**DEPARTMENT OF TRANSPORTATION
STATE OF GEORGIA**

FILE P. I. No. 110670-, Banks County **OFFICE** Preconstruction
NH-IM-85-2(171)
I-85 Widening from North of SR 15/US 441 **DATE** April 9, 2008
To North of SR 63

SUBJECT APPROVED REVISED PROJECT CONCEPT REPORT

REVISED PROJECT CONCEPT REPORT

STATE OF GEORGIA
DEPARTMENT OF TRANSPORTATION
OFFICE: **TYPICAL SECTIONS**
1-85 BANKS COUNTY
MAINLINE TYPICAL SECTIONS

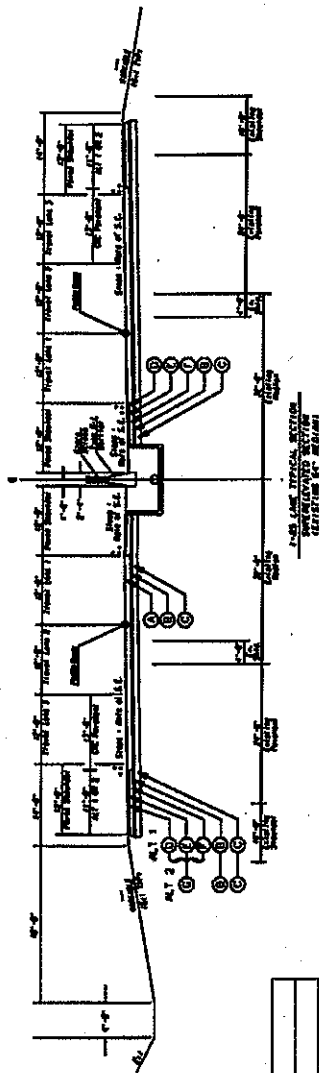
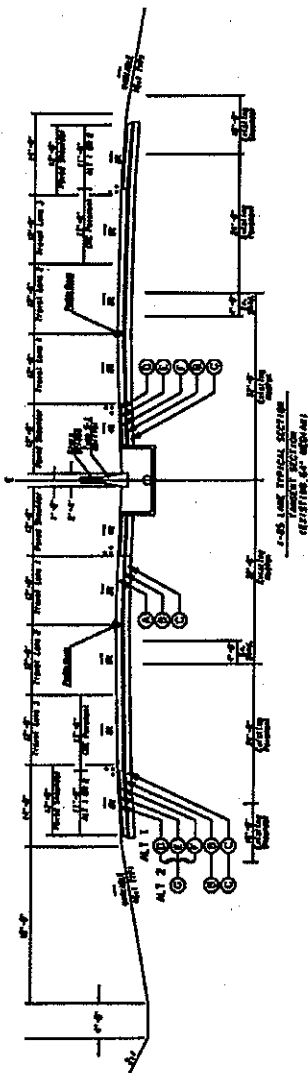
- **The revised typical section:**

Mile log 149.8-150.2 & 154.1-154.3

- Six 12' lanes, outside lane paving will extend 1'-0" into the paved outside shoulder but will be striped at 12'-0"
- Median Barrier (Type S-1, S-2 or S-3)
- 13'-2" inside shoulder (12' paved)
- 14' outside shoulder (12' paved), includes 1'-0" extension of outside lane pavement
- Concrete pavement section with full depth reconstruction of existing pavement and an alternative pavement section (asphalt or concrete) for the paved shoulders

Mile log 150.2-154.1

- Six 12' lanes, outside lane paving will extend 1'-0" into the paved outside shoulder but will be striped at 12'-0"
- 128'-4" depressed median
- 14' inside shoulder (12' paved)
- 14' outside shoulder (12' paved), includes 1'-0" extension of outside lane pavement
- Concrete pavement section with full depth reconstruction of existing pavement and an alternative pavement section (asphalt or concrete) for the paved shoulders

STATE OF GEORGIA
DEPARTMENT OF TRANSPORTATION
OFFICE,
TYPICAL SECTIONS
1-85 BANKS COUNTY
MAINLINE TYPICAL SECTIONS

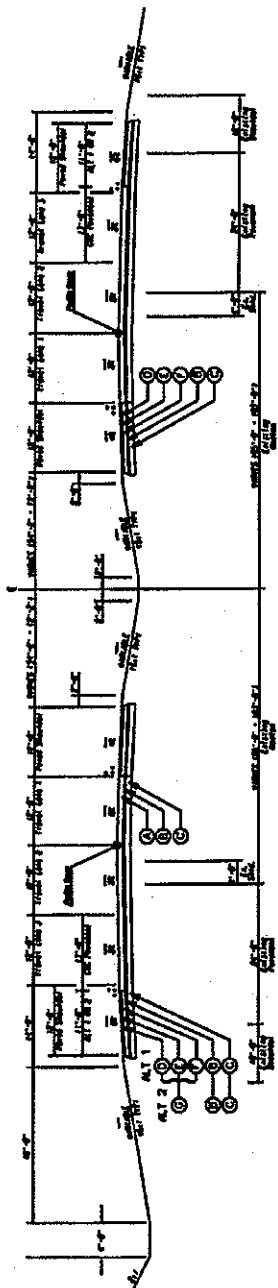
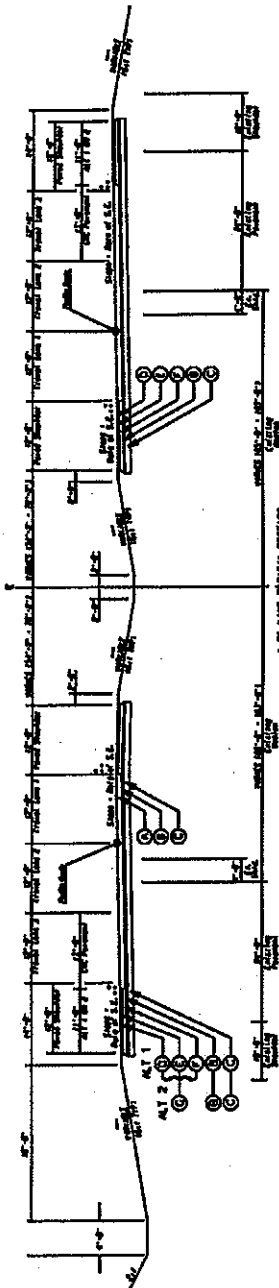
~~1-17 LANE ITALIAN SECTION~~
~~PAWING ST. SECTION~~
~~(EXISTING 170' - 205' MEDIAN)~~

1-25 TIME TYPED SECTION
